Closure Unit 4 Work Completion Report, Revision 1
Three Kids Mine
Henderson, Nevada

Project No. 23-01-200

Re: **Closure Unit 4 Work Completion Report, Revision 1**
Three Kids Mine, Henderson, Nevada

Figure 2	
Site Features Map – Closure Unit 4	
Three Kids Mine	
Designed	
Drawn	JCM
Approved

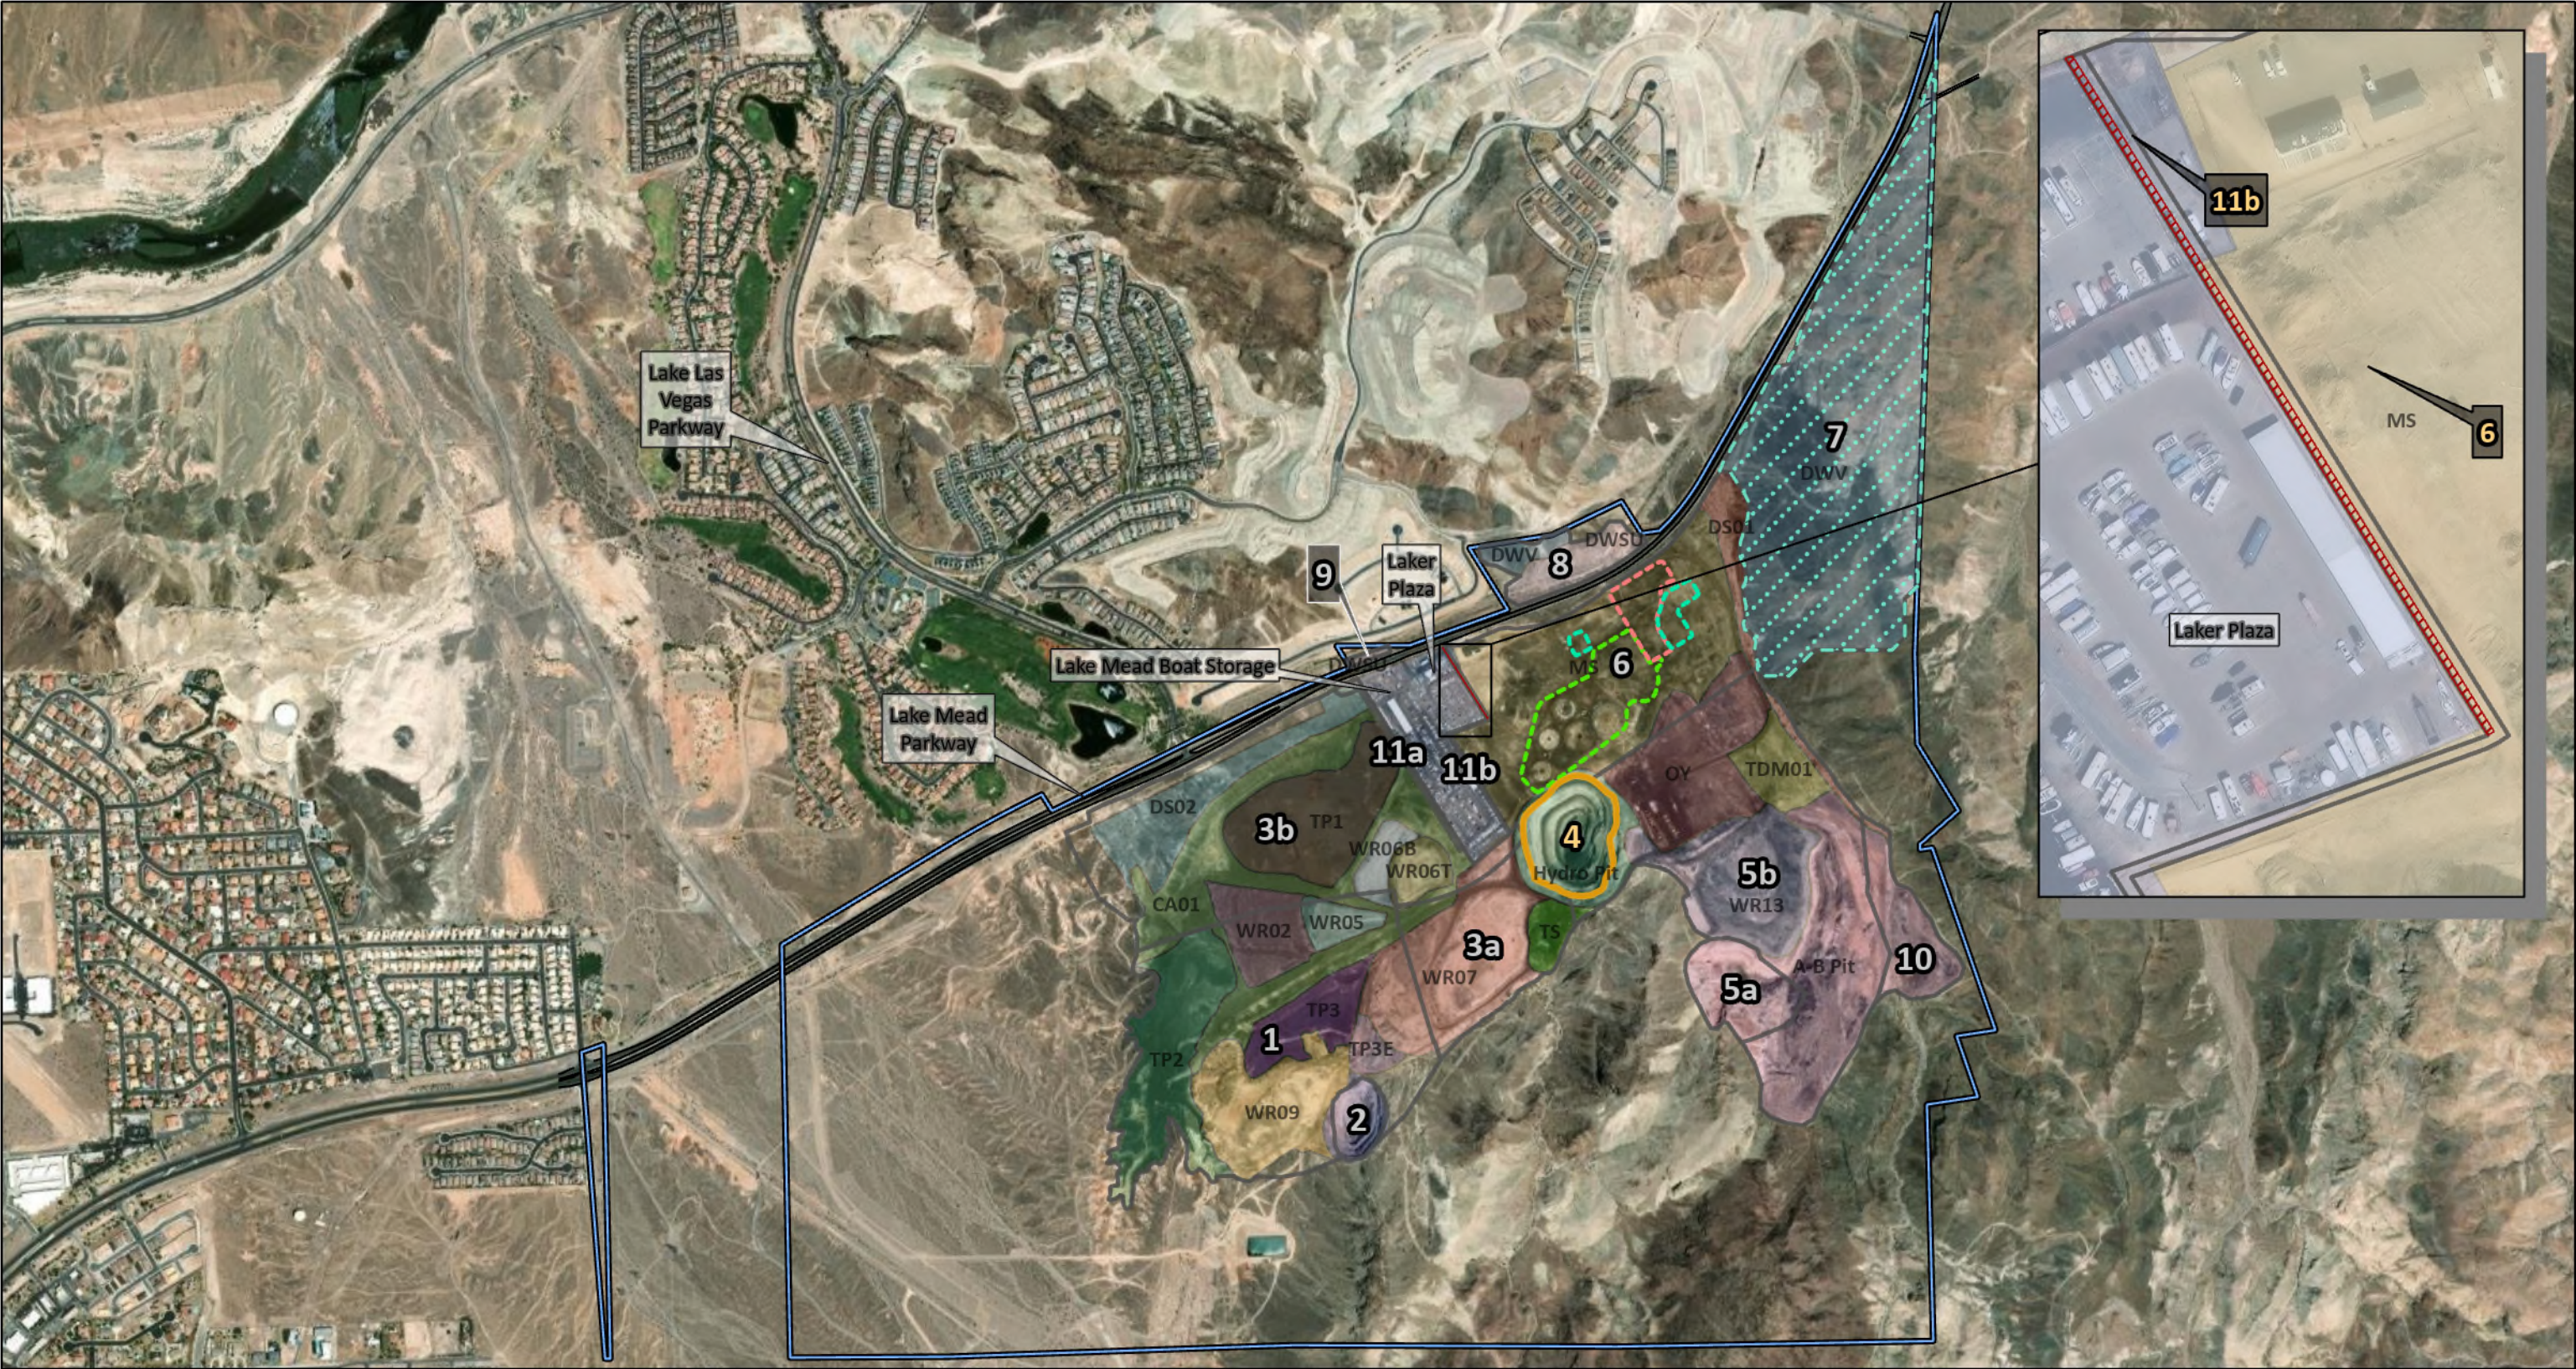
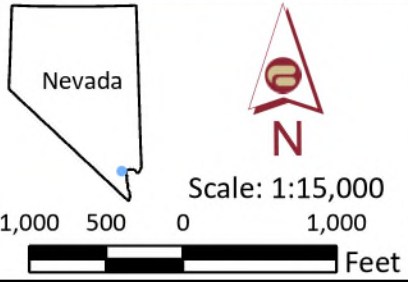
8. **Section 3.3 Tailings Remediation, Tailings Stockpile subsection** – It is not clear from Figure 10 where the tailings stockpile was located. Please describe its location and include a reference to Figure 2 where its location is labeled as “TS.”

A description of the location of the Tailings Stockpile area and reference to Figure 2 was added to Section 3.3, along with location descriptions for the tailings ponds. Additionally, the edge of the Hydro Pit was labeled in Figure 10.

Figure No. 3
Sitewide Asbestos Work Areas

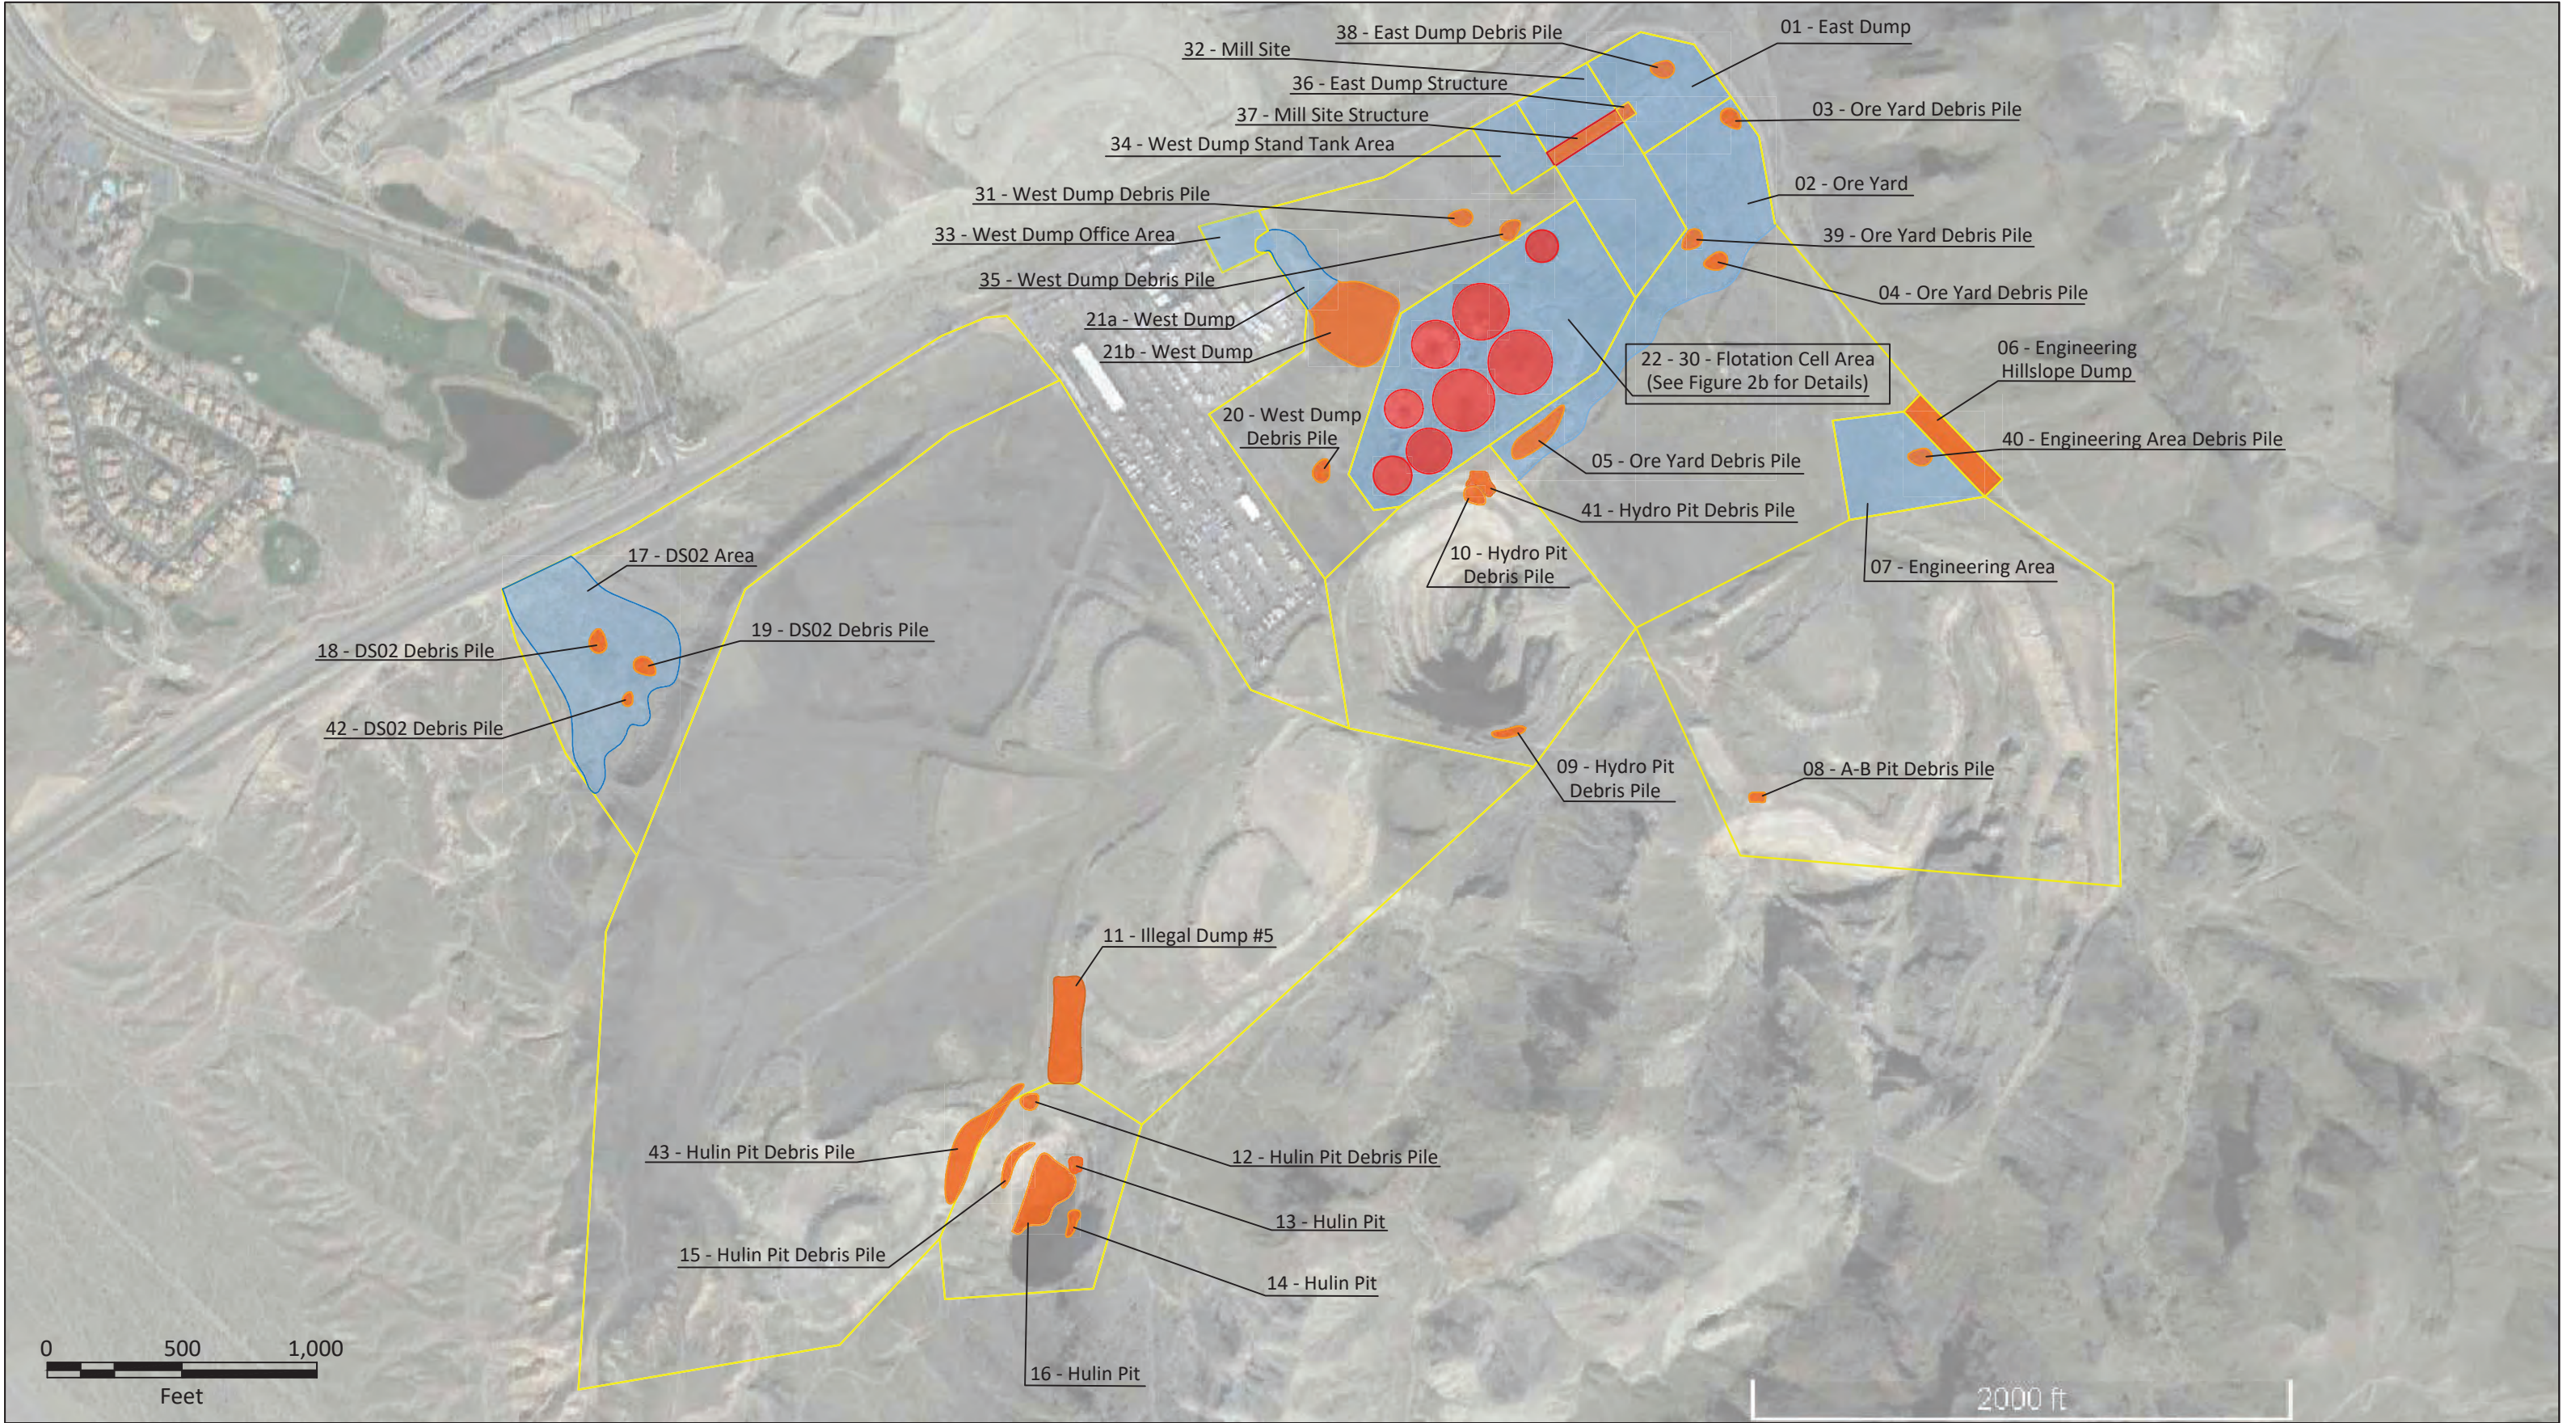
3. **Section 3.1 Asbestos Abatement** – This section indicates that two locations (09 and 10) were abated for this work; however, Figure 3 identifies area 41 as being directly next to Area 10. Was it removed for the haul road also? Suggest including Area 41 here to be consistent with the figure.

21. **Figure 3, Sitewide Asbestos Work Areas** – The legend indicates that RACM was removed from area 9 (Hydro Pit Debris Pile). However, Section 3.1 (Asbestos Abatement) states that “Location

09 was covered and left in place within the Hydro Pit” (with permission). Please correct this discrepancy.

Information regarding location 41 was added to Section 3.1.

The legend in Figure 3 was changed to identify that RACM was abated in areas indicated.
